Product Change Notice (PCN)

Subject: Site addition of package assembly, and final test

Renesas plans to add the site of assembly/final test for RZ/T2M 320BGA, 225BGA, and RZ/N2L 225BGA to realize stable supply. Renesas would like to deliver products produced in the added site for your orders.

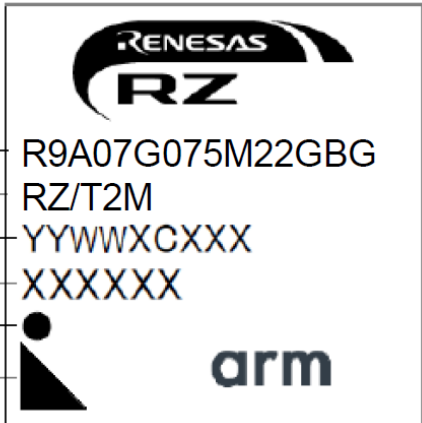
The assembly site, and Final-Test site are added as follows:

(Continues the production at current site and supports in parallel production)

Changing items	Current	After change	Impact
Assembly site addition	Assembly site: ASE-KH	Additional site: SPIL	<ul style="list-style-type: none"> Part number: No change Material: Change Mark: Change (Lot# only) Outline dimensions: No change Machine: Change Product characteristics and quality: Equivalent
Final test site addition	FT site: KYEC	Additional site: TeraPower	<ul style="list-style-type: none"> Machine: No change Test specification: No change Packing specifications: No change
